STOCKING PELHAM –
ENERGY
DEVELOPMENT SITES

Acoustic Appraisal

Reference: 12622.RP01.ENS.1
Prepared: 27 November 2023
Revision Number: 1

Appendix B within Pelham Substation Acoustic Report showing noise level predictions

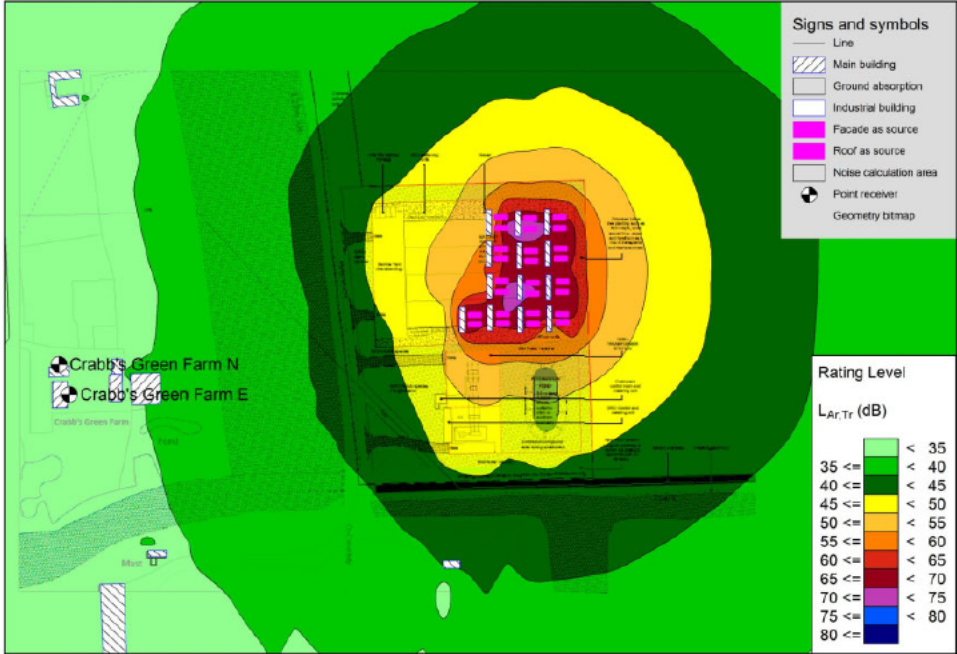
“Although there is a peak in the sound power levels at 3.15 kHz, the high frequency levels are attenuated more over distance than low frequency, and therefore there are no prominent tones at the receptor locations modelled. Therefore, it is expected that the sound would not contain any acoustic features and no acoustic feature correction has been added to the specific sound level to derive the rating level.”

Although it is true that higher frequencies are more readily attenuated in air, given that the distances involved in this assessment are relatively small (around 180m), the difference in attenuation at different frequencies is unlikely to be so significant that the above statement is justification alone for discounting the potential for tonality. Further to this, tonality of the resulting octave band levels could be determined through octave-band analysis, using the Objective Method described in BS4142:2014 (and summarised above in Section 3.2 of this report).

Figure 2 within Crabbs Lane Acoustic Report showing proposed plant items

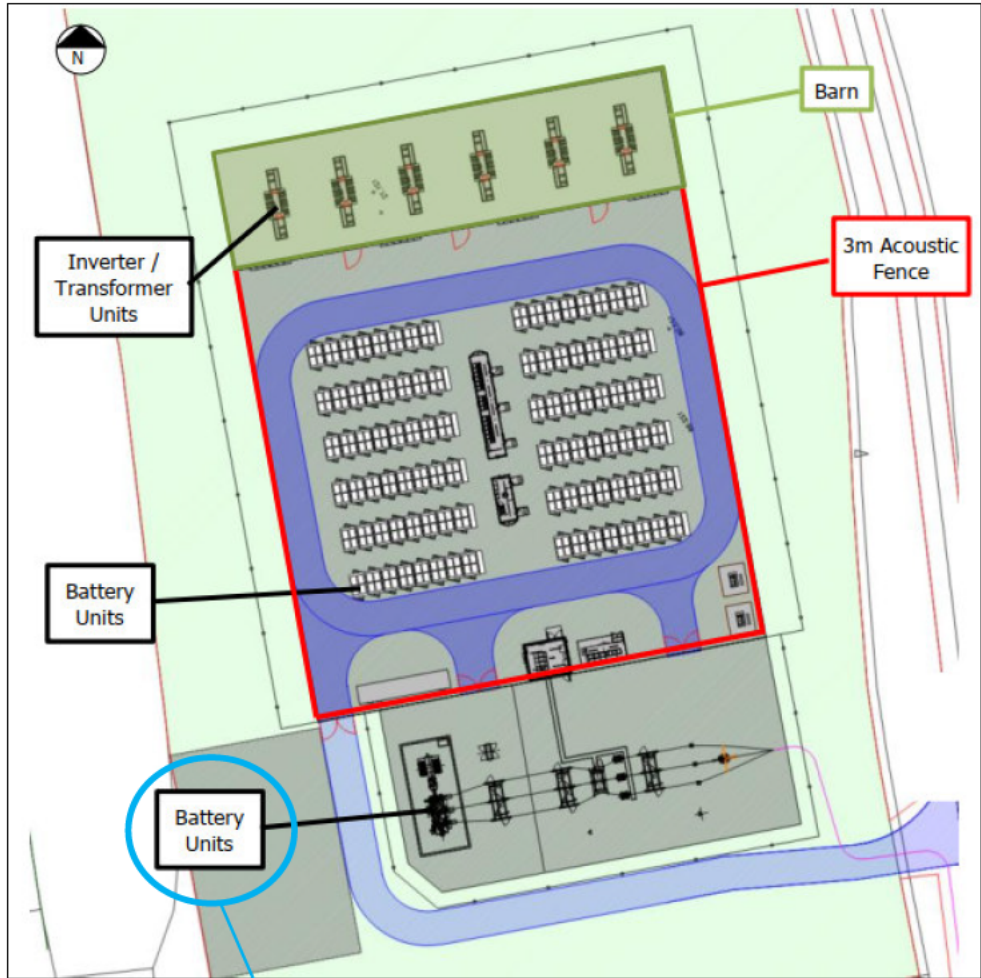
We believe this is a typo and should be labelled as 'Distribution Network Operator (DNO)'

Figure 4.1 within Berden Hall Acoustic Report showing typical 'ramping-up' of sound pressure level of a solar inverter during early hours of the morning

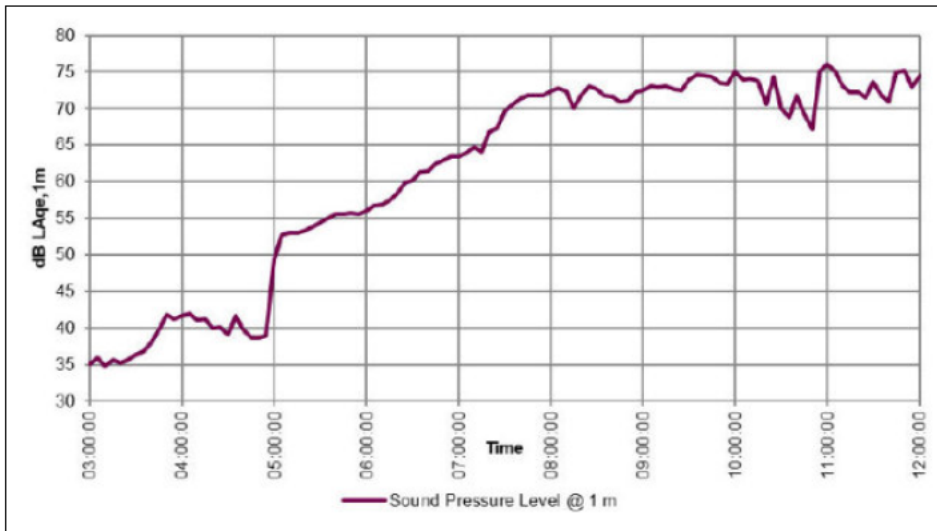
Justification for the reduced inverter noise level duty for the 05:00-07:00 period is given in Section 4.6 of the report, as shown in their Figure 4.1, repeated in Figure 5 of Appendix C of this report.
